DTB

Date: April 23, 2009
 Order No.: S-B-03.30/08i
 Supersedes: S-B-03.30/08h dated October 24, 2008
 Group: 03

SUBJECT: **Model 164.156/172/186/871/886**
Model 171.454/456
Model 203.052/054/056/087/092
Model 204.054/056/081/987
Model 209.356/372/456/472
Model 211.056/072/087/090/256/287
Model 216.371/386
Model 219.372
Model 221.171/186
Model 230.471
Model 251.156/165
Equipped with M272 or M273 Engine
Check Engine Light On / Fault Codes Current and/or Stored in ME-SFI Control
Module / Oil Leaking at Camshaft Adjustment Solenoid

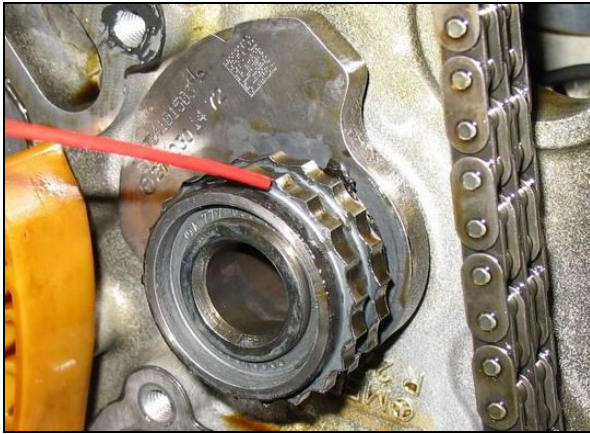
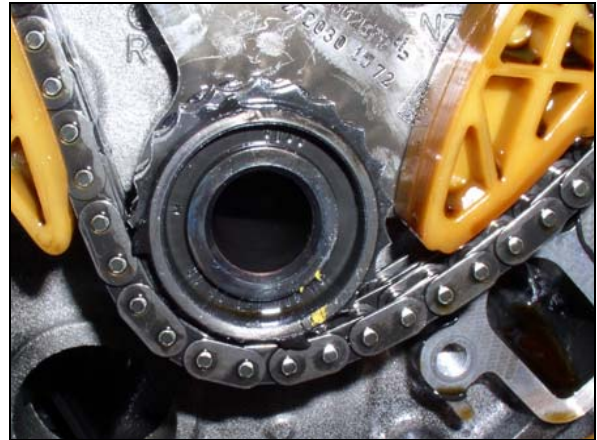
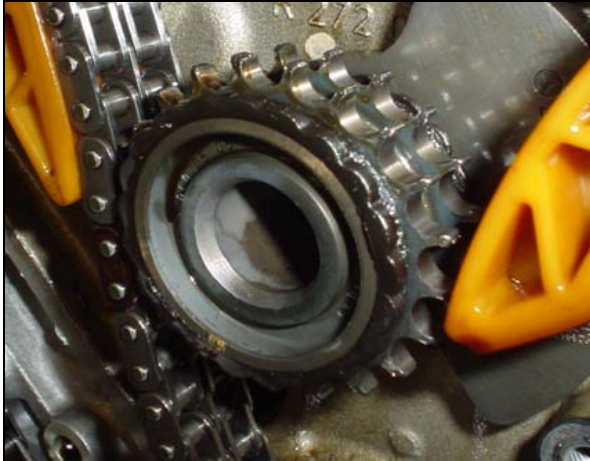
Fault Code Scenario 1: DTC ^{P0017} 1200 ^{P0016} and/or 1208 is/are present in ME-SFI control module. The fault codes are recorded as current and/or stored in the fault memory. When the fault memory is erased and the engine is restarted, the fault codes reoccur immediately. This is due to the positioning of the timing chain driven camshafts relative to the crankshaft and **can be caused by a worn sprocket on the balance shaft** on engine M272 or by a worn guide (idler) gear for the timing chain on engine M273. Figure 1, 2 and 3 show extremely worn sprocket gears. Figure 4, for comparison, shows a new sprocket gear.

- a) Perform a visual inspection for any wear of the teeth (damage profile) on the sprocket of the balance shaft (M272) or of the guide (idler) gear for timing chain (M273) by removing the timing case cover on the engine. Refer to WIS instructions AR01.40-P-8000* (* - applies to a specific model designation e.g. AR01.40-P-8000SX – models 221, 216). Ensure the use of the Special Tool W001 589 81 09 00 when removing / installing timing case cover.

i **Note:** Refer to Figure 1 through 3 for examples of damaged / worn sprocket profile. Refer to Figure 4 for example of a new gear (for comparison).

- b) Only if worn (sprocket teeth profile damaged), replace the balance shaft on engine M272 or replace the guide (idler) gear of the chain drive on engine M273 as per WIS instructions AR03.20-P-1000* (* - applies to a specific model designation e.g. AR03.20-P-1000VA – model 171).

Figure 5

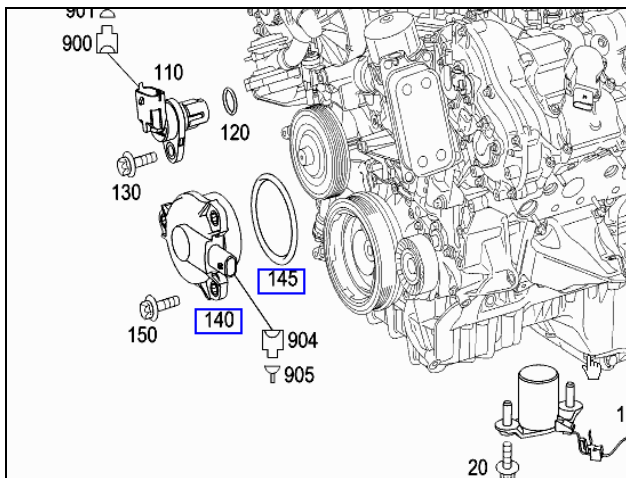
Fault Scenario 3: Camshaft adjustment solenoid is leaking oil, and no Fault Codes are current or stored in the ME Control Module. Determine the cause of the leak. The solenoid can be leaking from under the sealing ring or through the harness connector.

- a) If the leak appears to be between the solenoid and the cylinder head replace solenoid sealing ring (Figure 5, 145).
- b) If the leak is from the electrical connector, replace the solenoid (Figure 5, 140).
